Access Compliance Report Public Rights-of-Way (Curb Ramps)

Main Street: S_SELLAS_RD		Cross Street: TUBEROSE_ST		Location:	NW
ADA ID: RPRK211103140821	Ramp Type:Type 1 - Perpendicular	Initial Pass/Fail: Fail	Overall Compliance: No	Severity Score:	15
Codes/Mitigation Info/Possible Solution			Field Measurements/Component Compliance

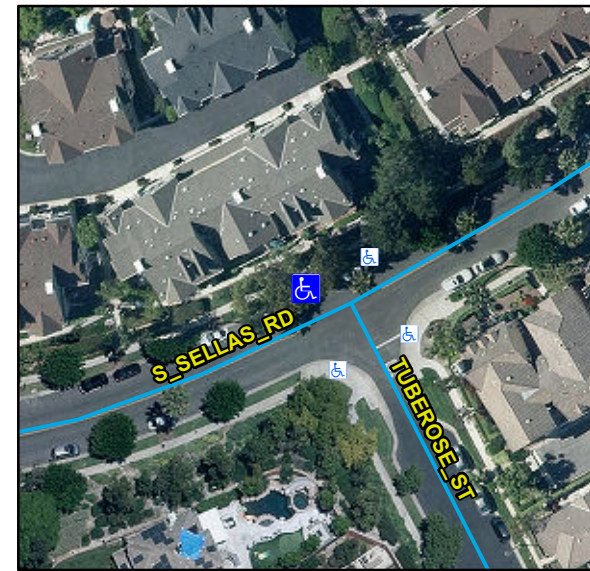
Compliance	Description	Data	Compliance	Description	Data
N/A	Ramp Length (in)	67	N/A	Flare Type LT	
Yes	Ramp Width (in)	48			N/A
No	Ramp Run Slope (%)	10.4	N/A	Flare Slope LT (%)	N/A
Yes	Ramp Cross Slope (%)	3.2	N/A	Flare Traversable LT	N/A
N/A	Landing Present	N/A	N/A	Flare Type RT	
N/A	Landing Length (in)	N/A			N/A
N/A	Landing Width (in)	N/A	N/A	Flare Slope RT (%)	N/A
N/A	Landing Run Slope (%)	N/A	N/A	Flare Traversable RT	N/A
N/A	Landing Cross Slope (%)	N/A	N/A	DWS Provided	N/A
N/A	Landing Movement Obstructed?	N/A	N/A	DWS Contrast	N/A
	Landing Movement Type	N/A	N/A	DWS Length (in)	N/A
N/A	Landing Shared	N/A	N/A	DWS Full Width	N/A
N/A	Clear Space	N/A	N/A	DWS Offset Left (in)	N/A
N/A	Clear Space To Crosswalk (in)	N/A	N/A	DWS Offset Right (in)	N/A
N/A	Marked Crosswalk 1	No	N/A	Marked Crosswalk 2	N/A
	Crossing 1 Direction	S		Crossing 2 Direction	N/A
	Marked Crosswalk 1 Width (in)	N/A		Marked Crosswalk 2 Width (in)	N/A

Remove & Replace Entire Ramp.

R304.2.2, STD 1115
